RE: DOCKET NO. 50-261

CAROLINA POWER & LIGHT COMPANY
H. B. ROBINSON STEAM ELECTRIC PLANT
UNIT No. 2

RESPONSE TO STATE AND FEDERAL
AGENCY COMMENTS ON THE
DRAFT ENVIRONMENTAL STATEMENT

Environmental Report
 Supplement No. 1
 H. B. ROBINSON STEAM ELECTRIC PLANT
 UNIT NO. 2
 INTAKE STRUCTURE
 Figure 3.4 a-1a

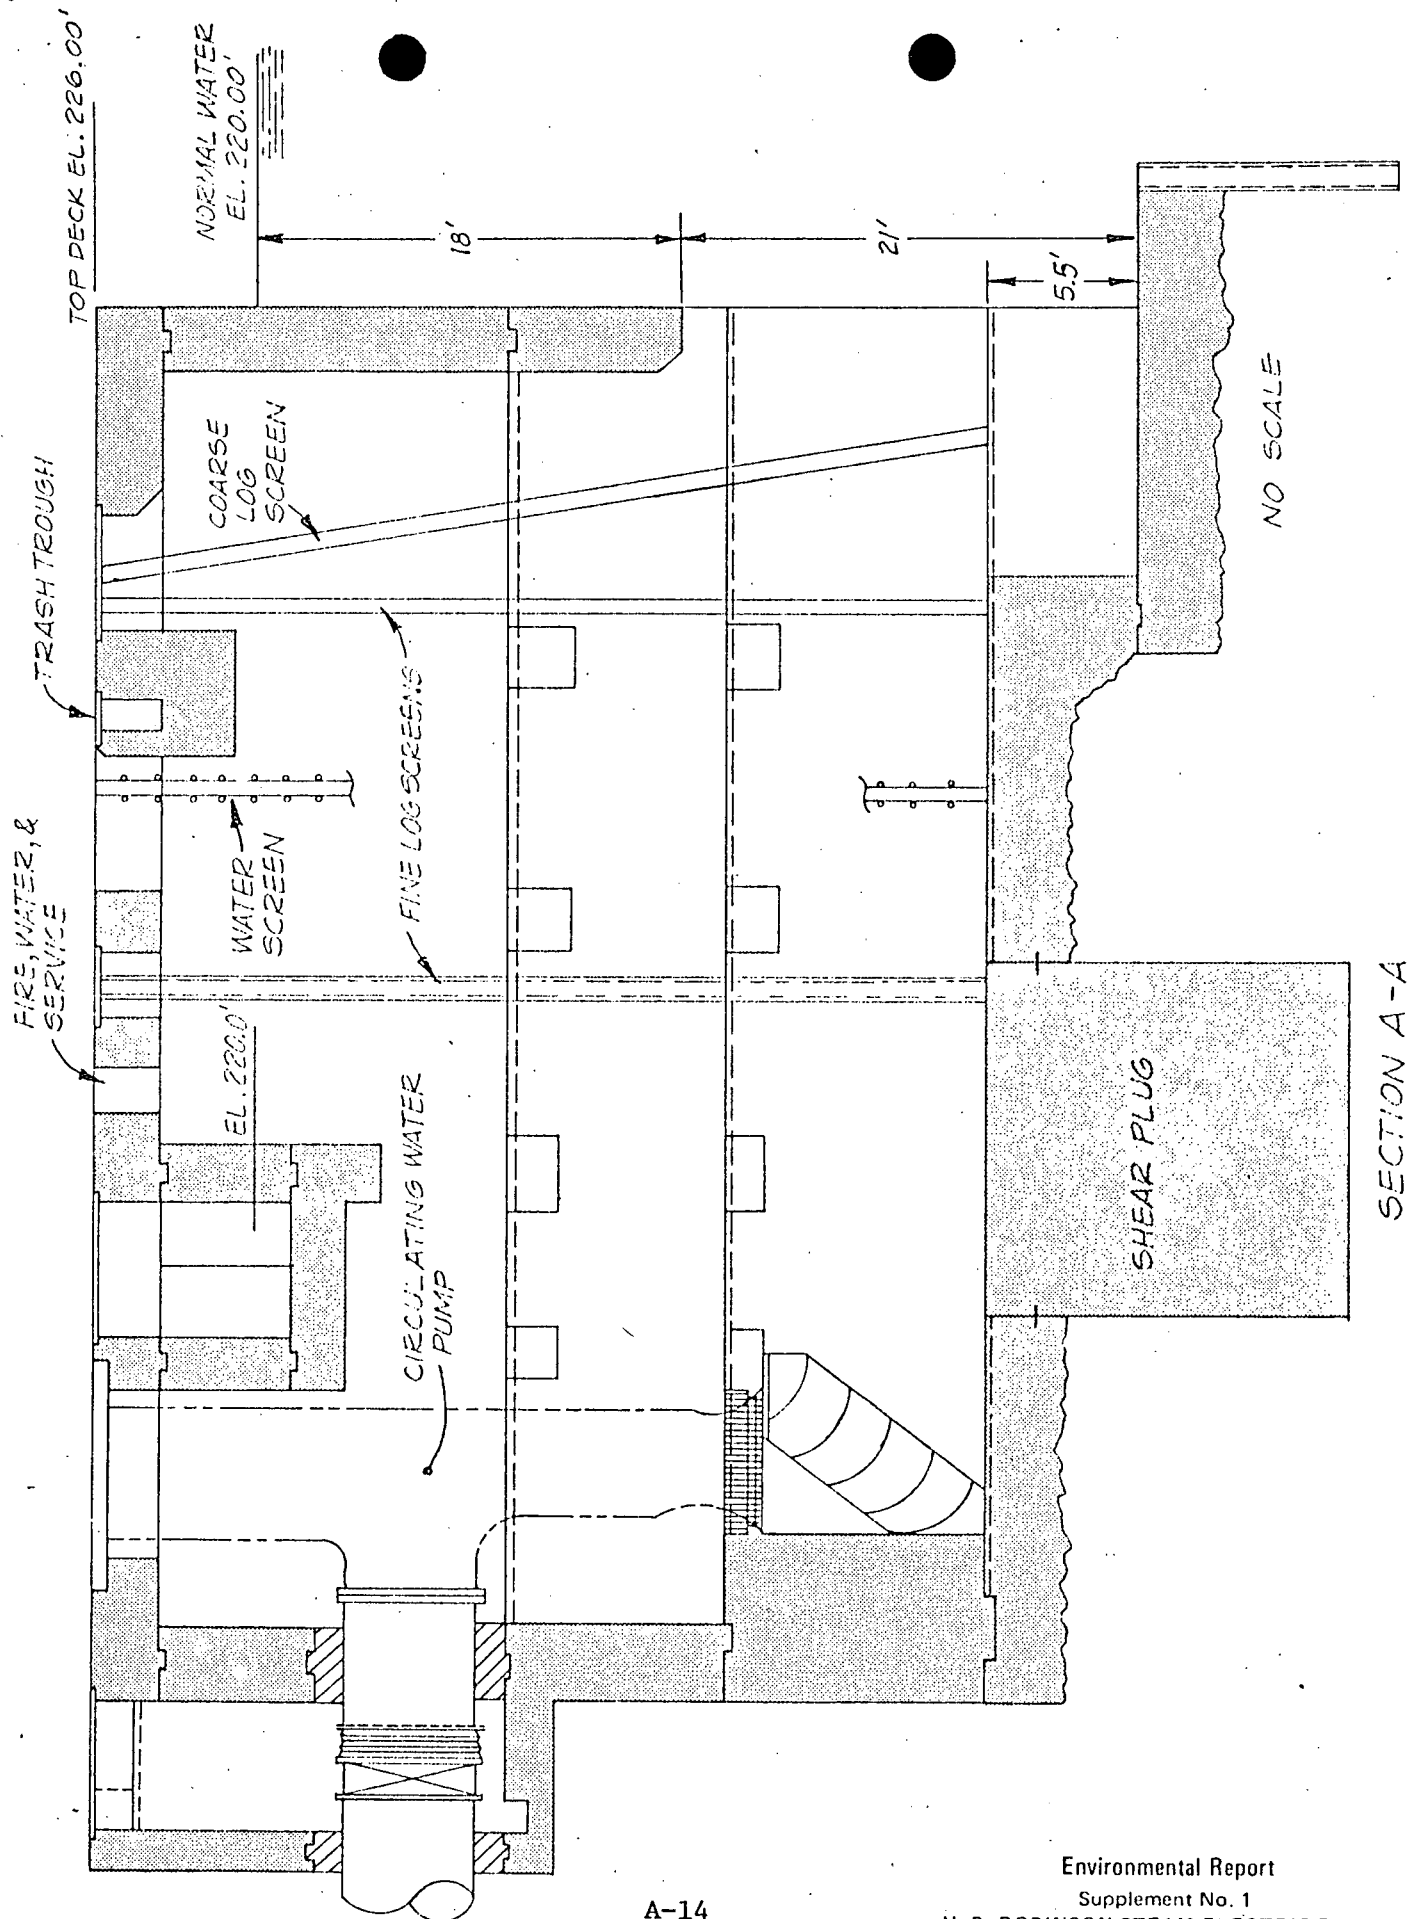
"We suggest that the scale be added to Figure 3.5 to better define the depths from which water is drawn." (Reference 1, page 5)

The revised figure is attached.
